3GPP TSG RAN WG1 Meeting #11
San Diego, USA, Feb 29-Mar 3, 2000

Document ***R1-00-0360***
e.g. for 3GPP use the format TP-99xxx
or for SMG, use the format P-99-xxx

25.211	**CR**	**043**	Current Version:	3.1.1

Subject:	Addition of a downlink physical channel indicating CPCH status

Figure 19: Structure of Acquisition Indicator Channel (AICH)

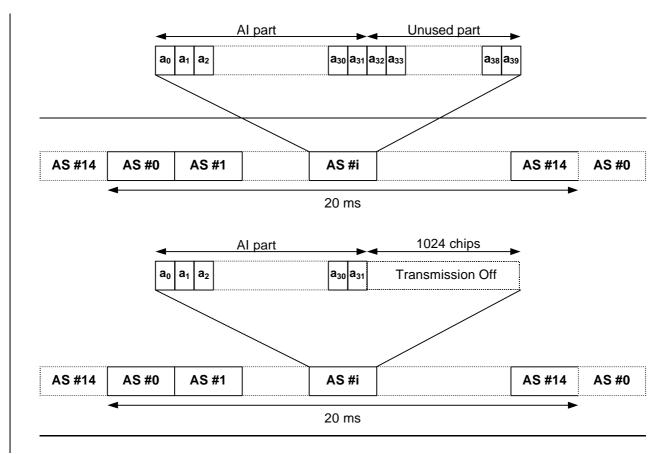
Figure 19 illustrates the structure of the AICH. The AICH consists of a repeated sequence of 15 concecutive *access slots* (AS), each of length 40 bit intervals. Each access slot consists of two parts, an *Acquisition-Indicator* (AI) part consisting of 32 real-valued symbols a_0, ..., a_{31} and ~~an unused~~a part ~~consisting of 8 real-valued symbols a_{32}, ..., a_{39}.~~ of duratoin 1024 chips with no transmission.

~~The real-valued symbols a_{32}, a_{33}, ..., a_{39} in Figure 19 are undefined.~~

Figure 23: Structure of CPCH Status Indicator Channel (CSICH)

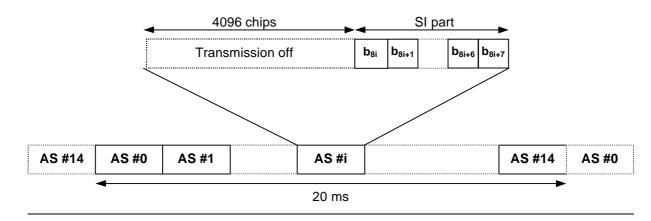
The CPCH Status Indicator Channel (CSICH) is a fixed rate (SF=256) physical channel used to carry CPCH status information. A CSICH is always associated with a physical channel used for transmission of CPCH AP-AICH and uses the same channelization and scrambling codes.

Figure 23 illustrates the frame structure of the CSICH. The 20 msec CSICH frame consists of 15 consecutive access slots (AS) each of length 5120 chips. Each access slot consists of two parts, a part of duration 4096 chips with no transmission, and a Status Indicator (SI) part consisting of 8 bits b_{8i}, b_{8i+1},….b_{8i+7}, where i is the access slot number. The phase reference for the CSICH is the Primary CPICH.

N Status Indicators {SI_0, …, SI_{N-1}} shall be transmitted in each CSICH frame where the allowed values of N are 1, 3, 5, 15, 30 and 60. The mapping from {SI_0, …, SI_{N-1}} to the CSICH bits {b_0, …, b_{119}} is according the following equation.
